Appendix 11

Results of Application Circulation Orlando File: C11E15.002

RE: Application for Draft Plan of Subdivision Part of Lot 14 & 15, Con 11 North Division Quarre Properties Inc. & Heartland (Seven) Limited City of Brampton, Ward 10

DRAFT PLAN OF SUBDIVISION QUARRE PROPERTIES INC. & HEARTLAND (SEVEN) LIMITED

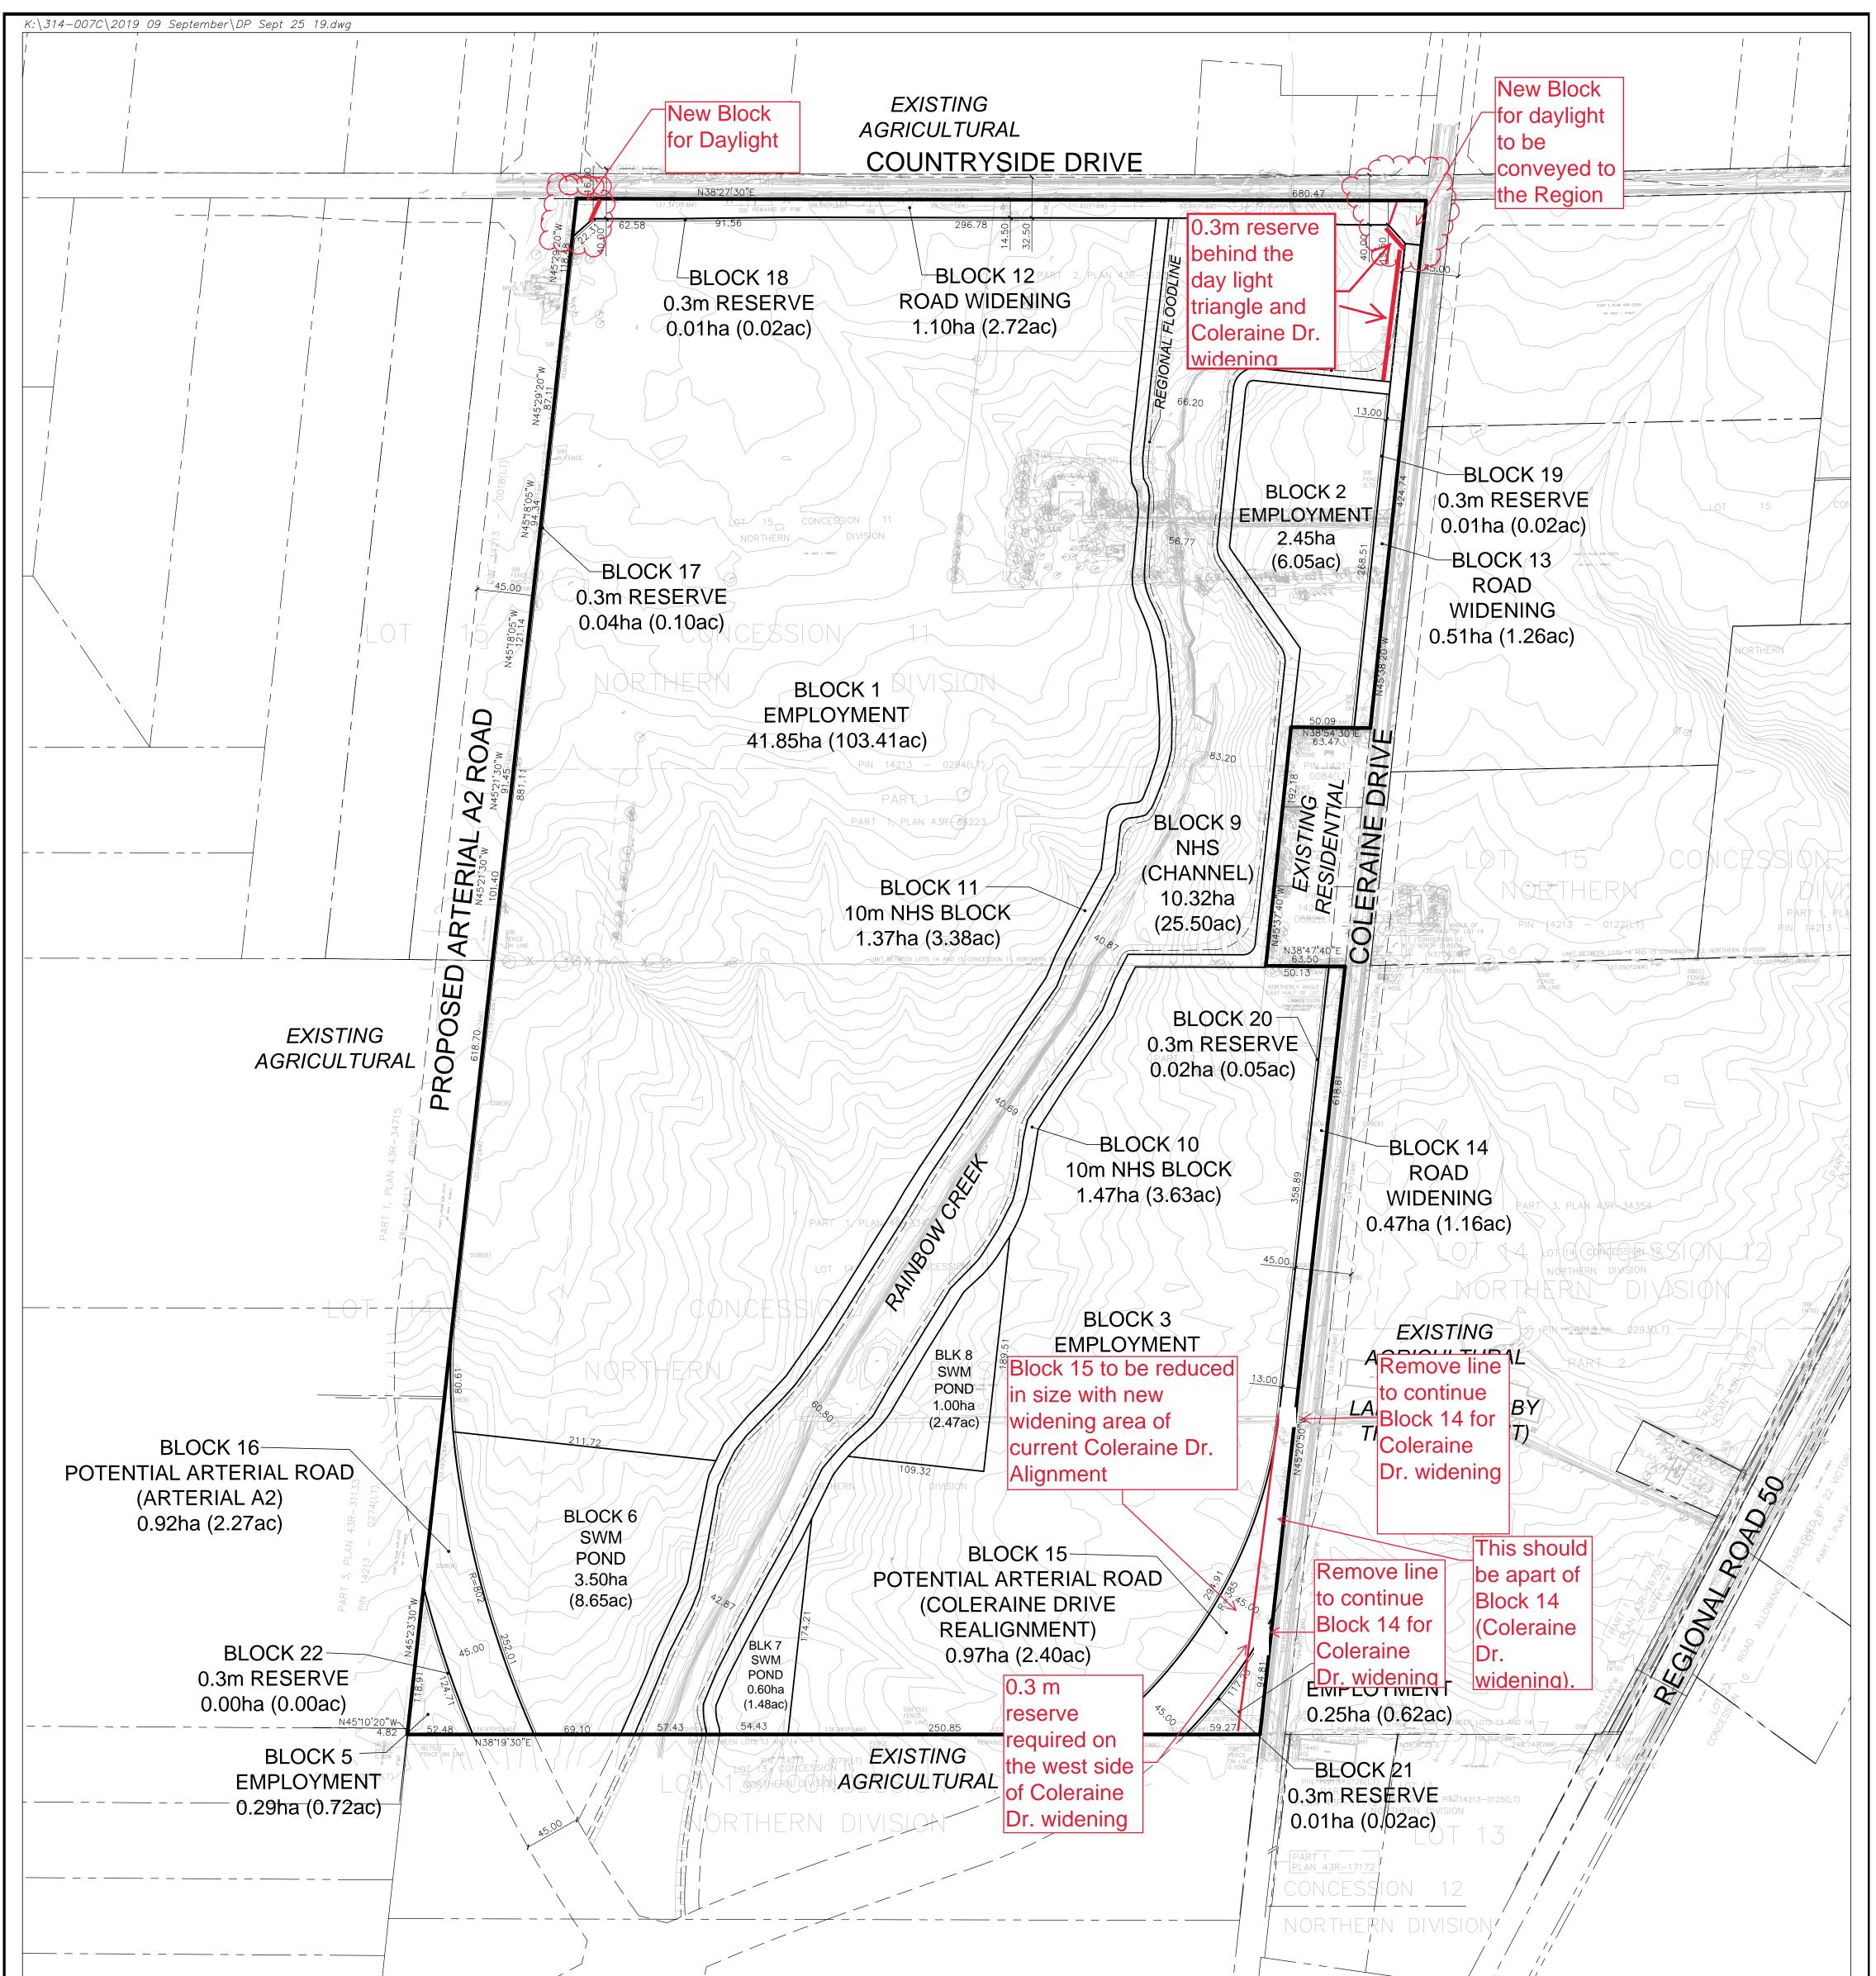
- 3. The applicant to provide overlays confirming that A2 Arterial Road and Coleraine Drive ROW alignments shown on the Draft Plan of Subdivision conform to the most recent EA road design. Revisions to the blocks may be required.

4. Revise Block 12 such that the Daylight Triangles and their associated reserves are recognized as separate blocks to be conveyed to the Region.

Please refer to the redline attached and update the Draft Plan of Subdivision accordingly.
